REVIEW ONLY - NOT FOR CONSTRUCTION

Drawing Title: ARCHITECTURAL - PARTITION TYPES

Project Title: RENOVATIONS TO BUILDING 217 - CLIN005

1 PARTITION TYPES

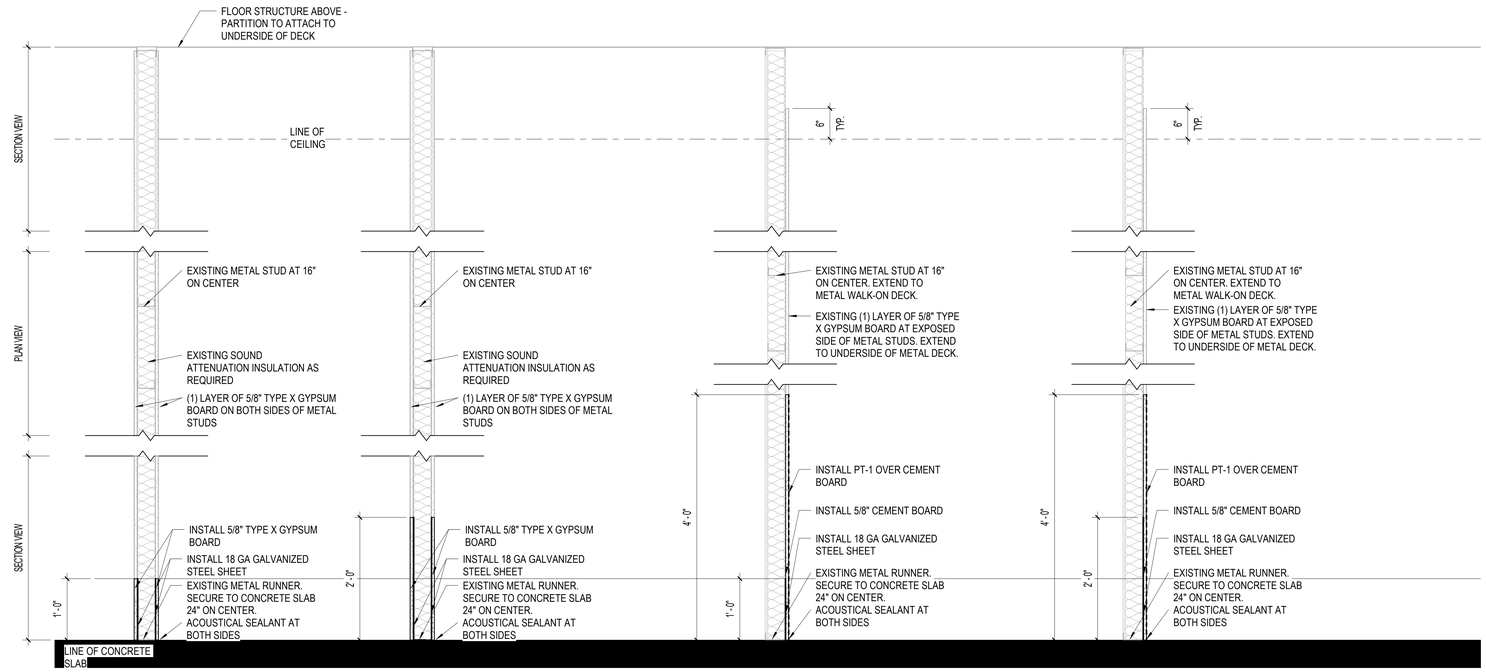
Install 18 gauge sheet metal -
2' aff along exterior walls (red lines),
1' aff along interior walls (blue lines).

Cut sheets for all penetrations (outlets, data drops, radiator piping, etc.) < 3/16" gap.

2 ARCHITECTURAL - ENLARGED PLAN - BARIATRIC C149

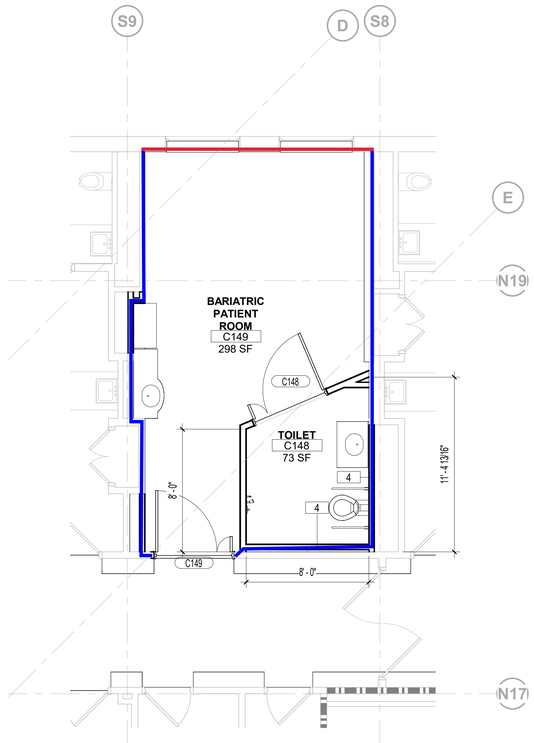
Install 18 gauge sheet metal -
2' aff along exterior walls (red lines),
1' aff along interior walls (blue lines).

Cut sheets for all penetrations (outlets, data drops, radiator piping, etc.) < 3/16" gap.

Drawing Title
ARCHITECTURAL -ENLARGED PLAN - HIGH FALL RISK ROOMS

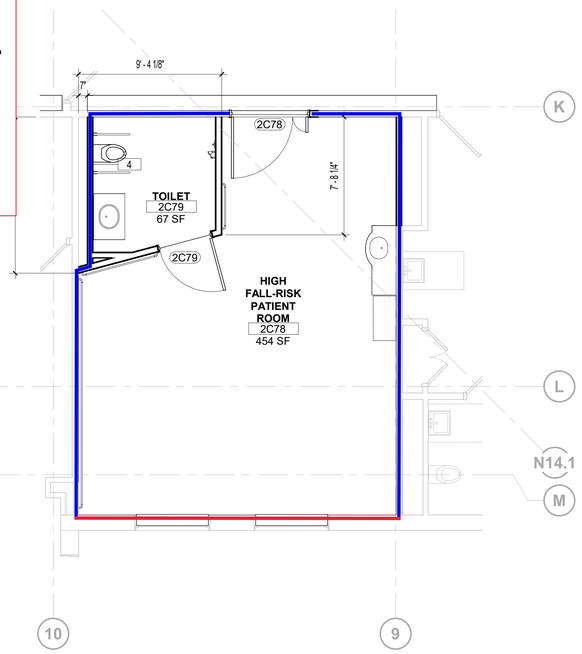
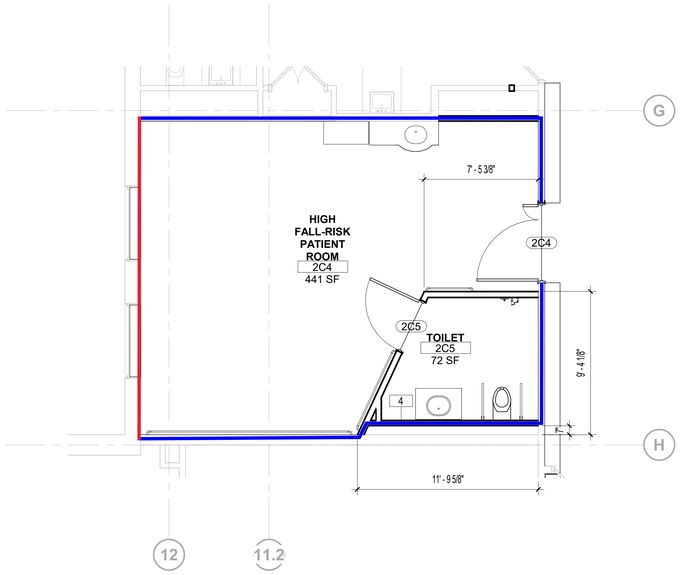
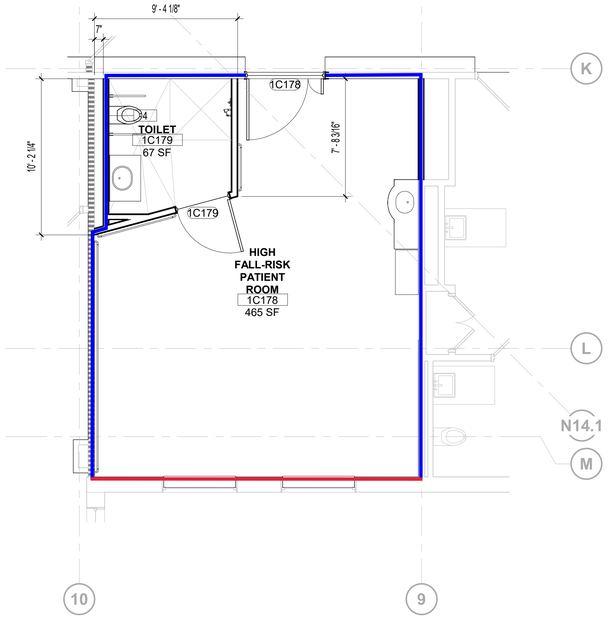
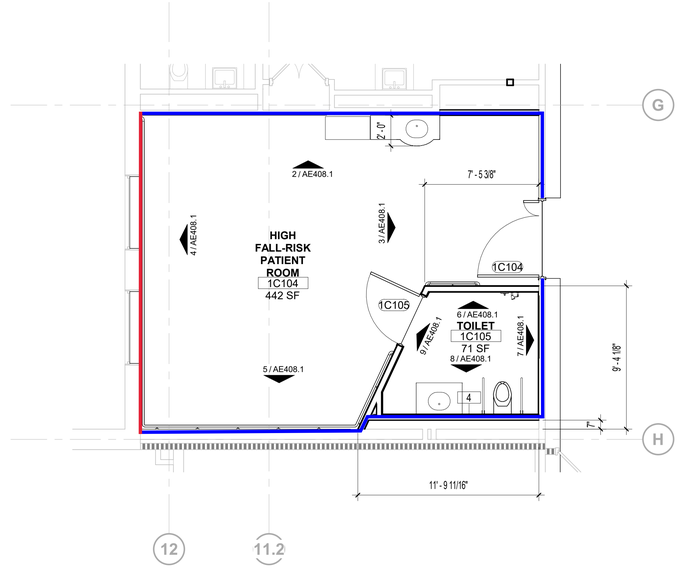
Install 18 gauge sheet metal -
2' aff along exterior walls (red lines),
1' aff along interior walls (blue lines).

Cut sheets for all penetrations (outlets, data drops, radiator piping, etc.) < 3/16" gap.
